ADDENDUM NO. 3

Warren Central High School Phase 3 Renovation and Addition 9500 E. 16th Street Indianapolis, IN 46229

This Addendum forms a part of and modifies the Bidding Requirements, Contract Forms, Contract Conditions, the Specifications and the Drawings dated January 3, 2023, by CSO Architects. Acknowledge receipt of the Addendum in the space provided on the Bid Form. Failure to do so may subject the Bidder to disqualification.

3.5 SHEET AD201F – FIRST FLOOR DEMOLITION PLAN – UNIT F

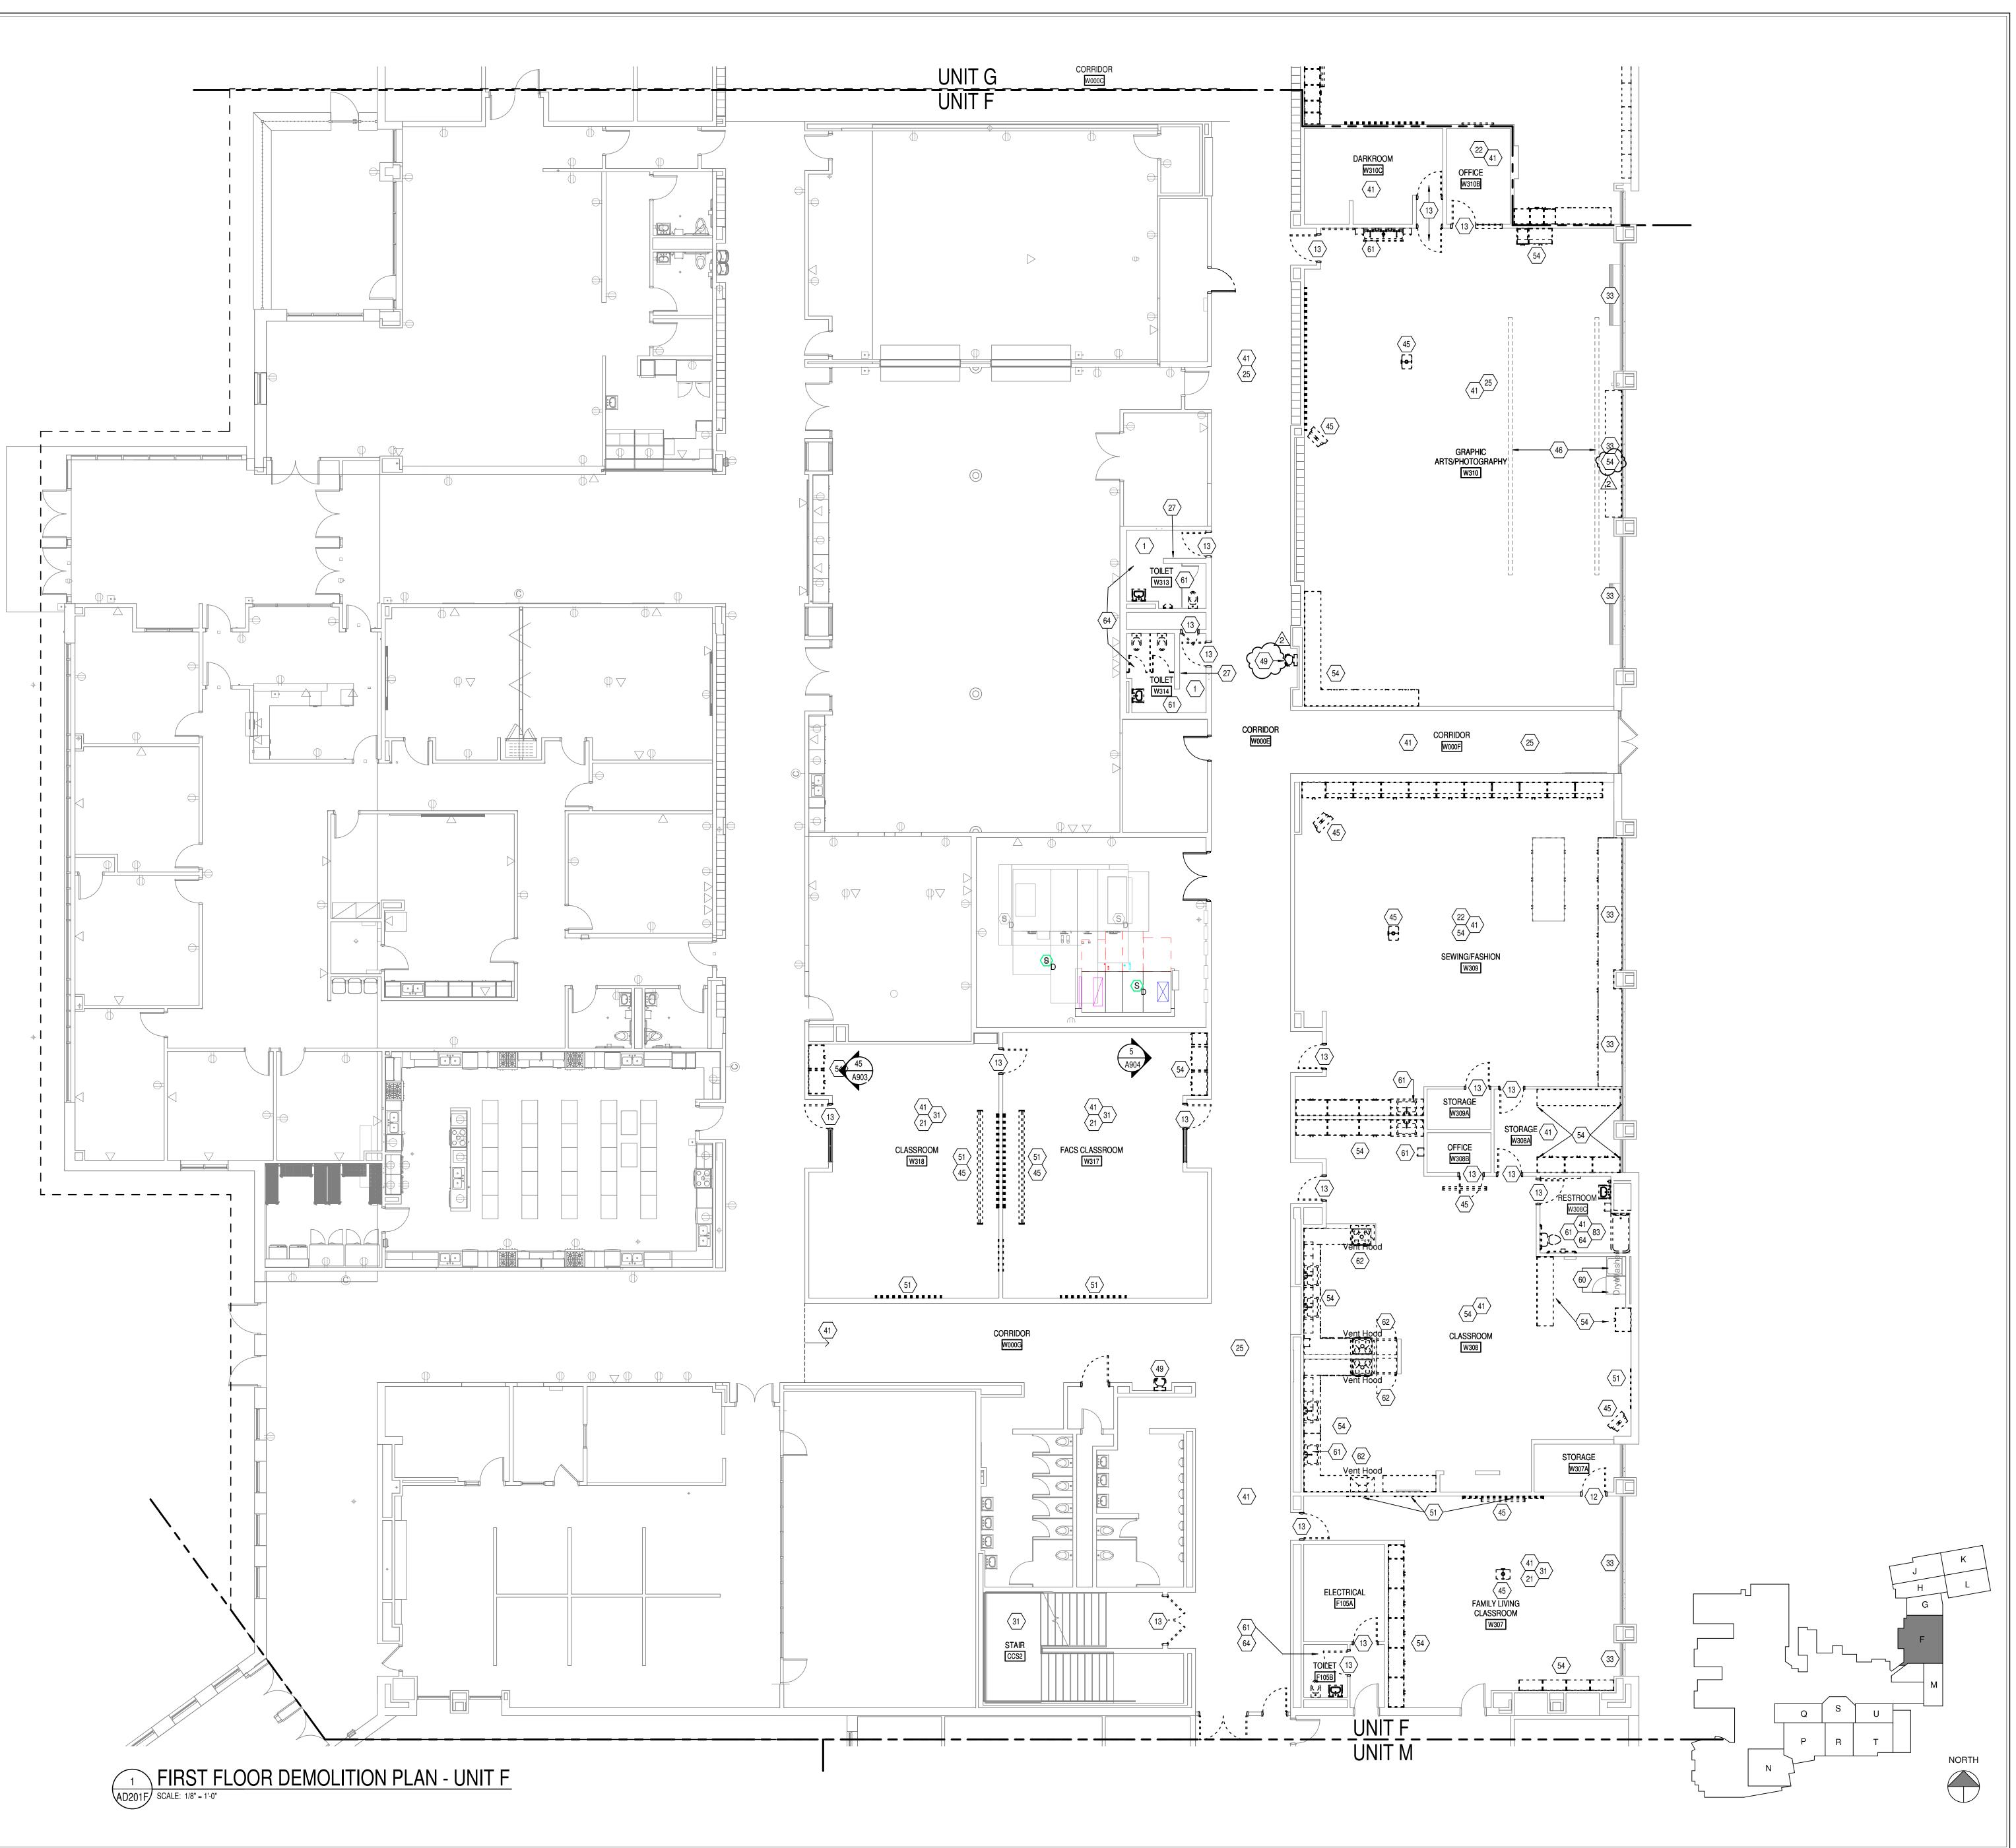
A. ADD demo notes as indicated on attached, re-issued Sheet AD201F.

DRAWING NUMBER A202N PROJECT NUMBER

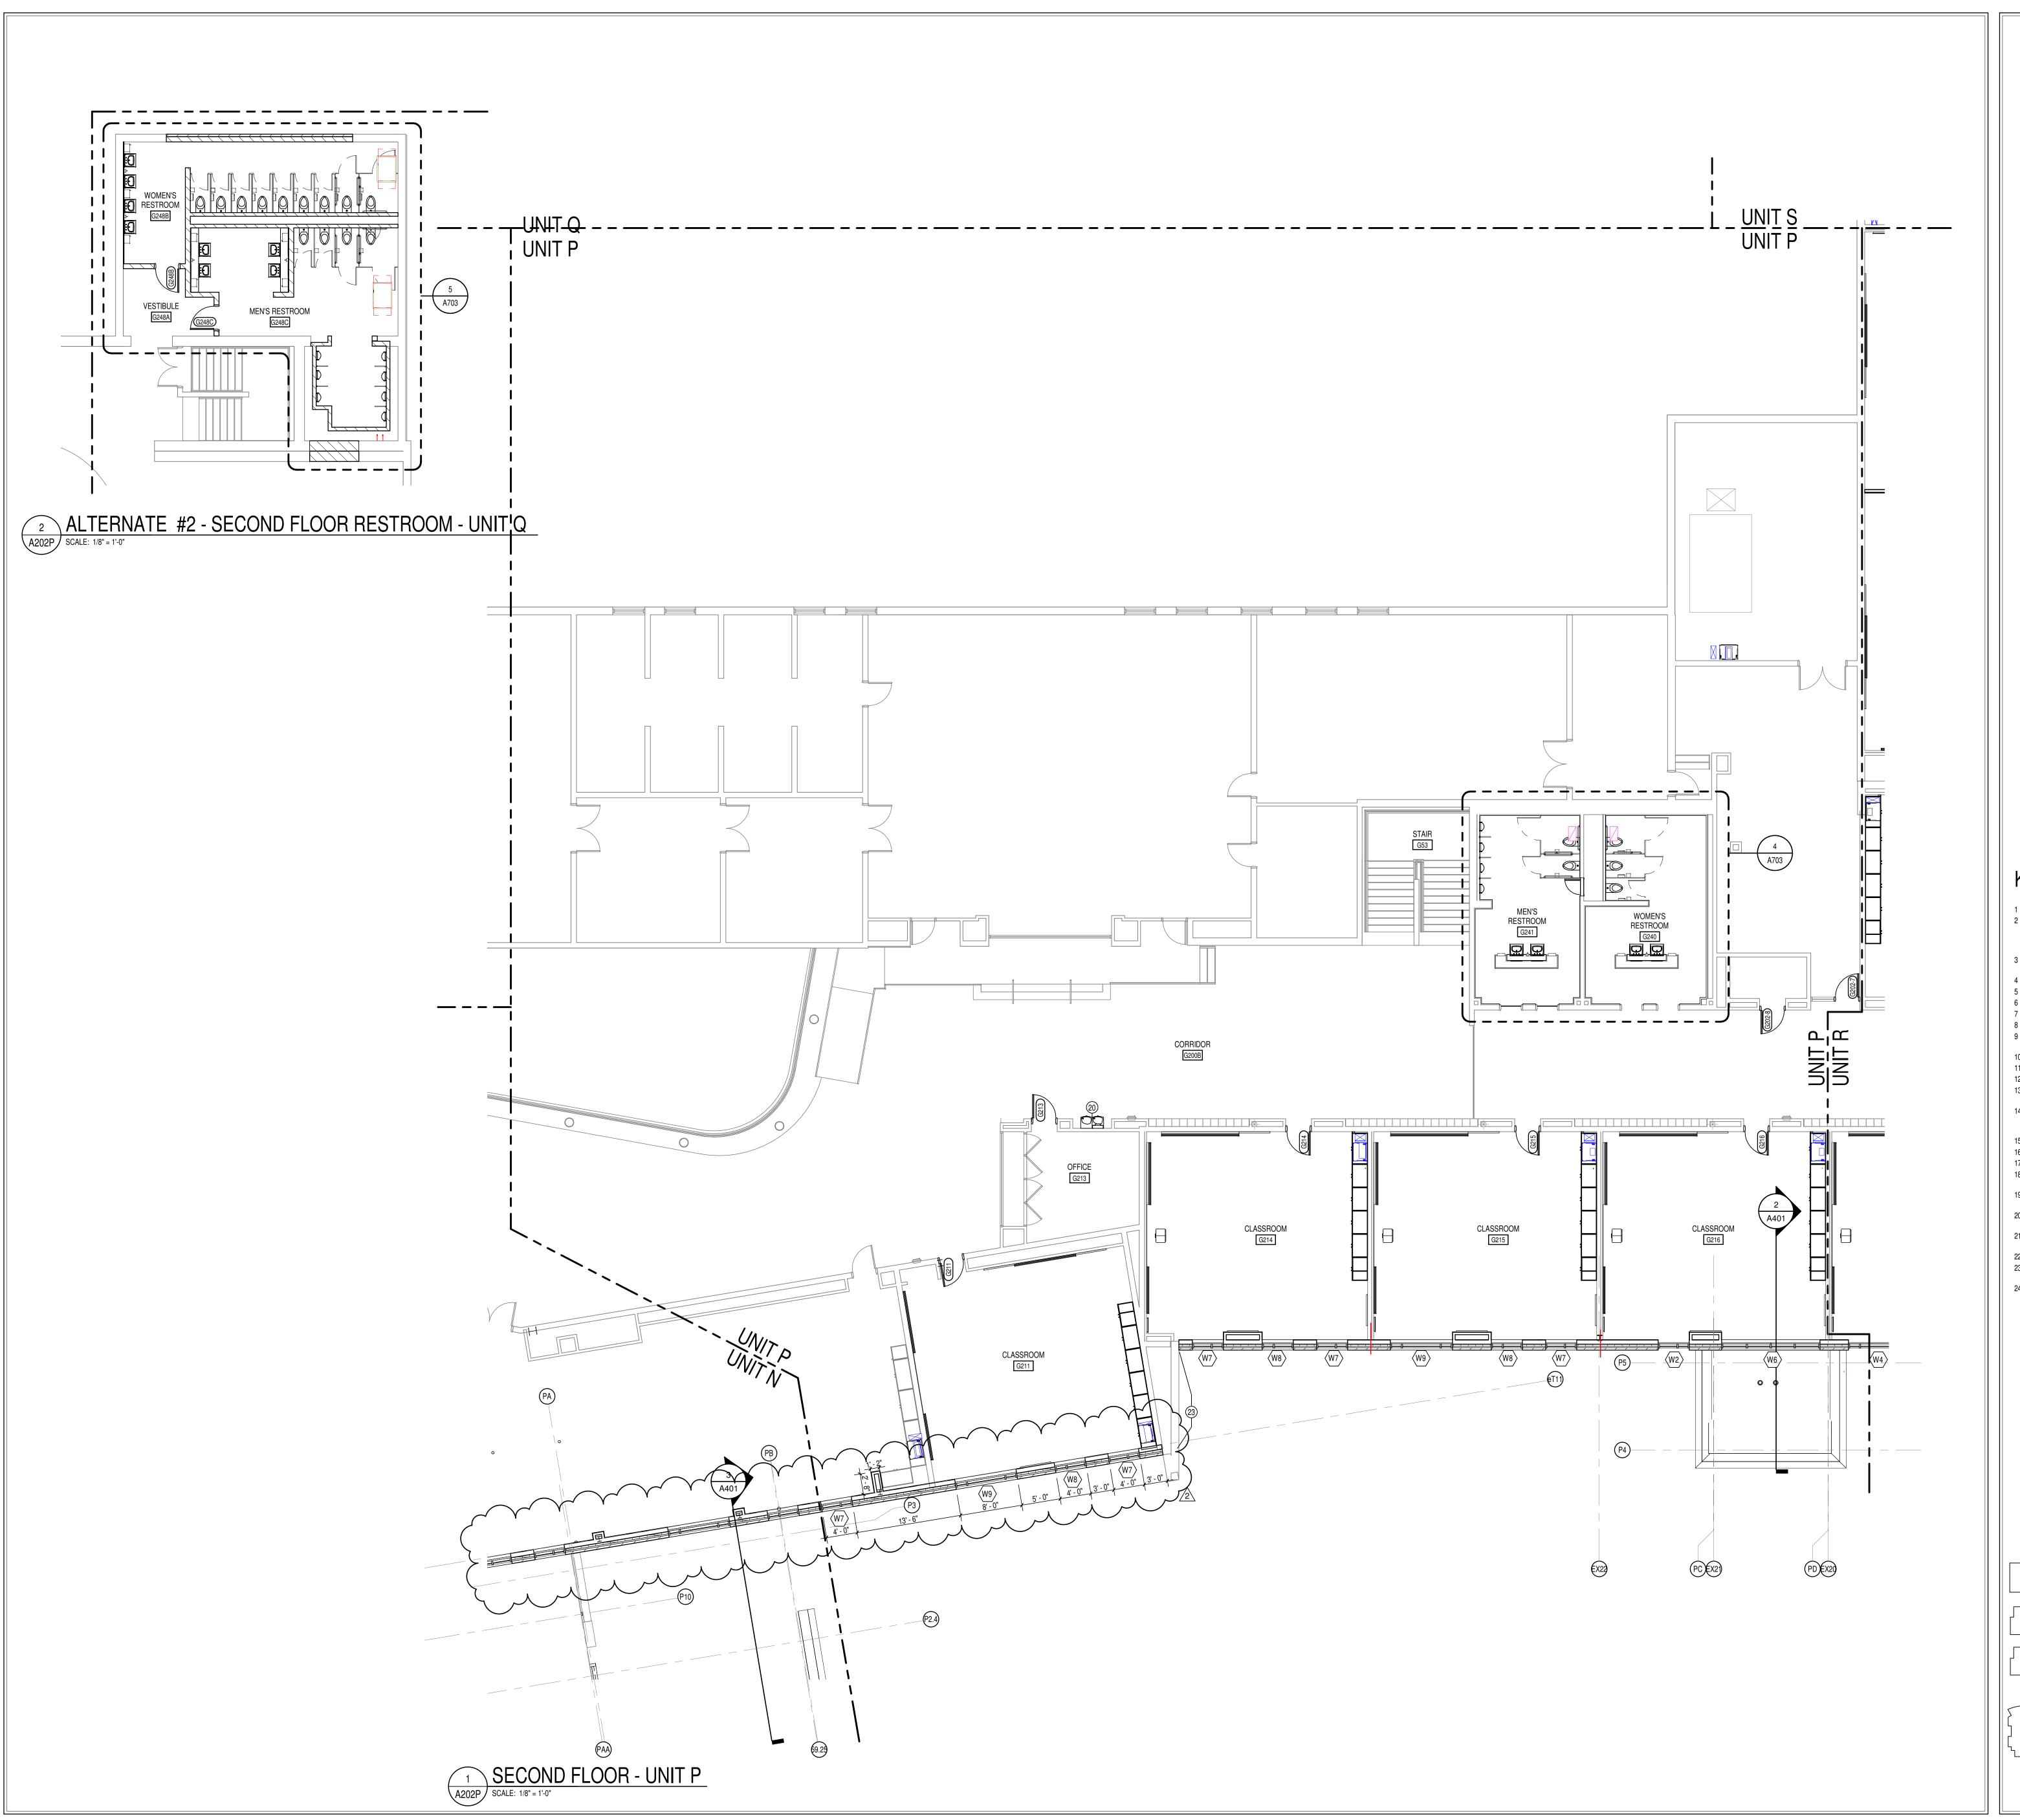
A. ADD Window reference tags to Alternate Plan 3/A202N as indicated on attached, re-issued Sheet A202N.
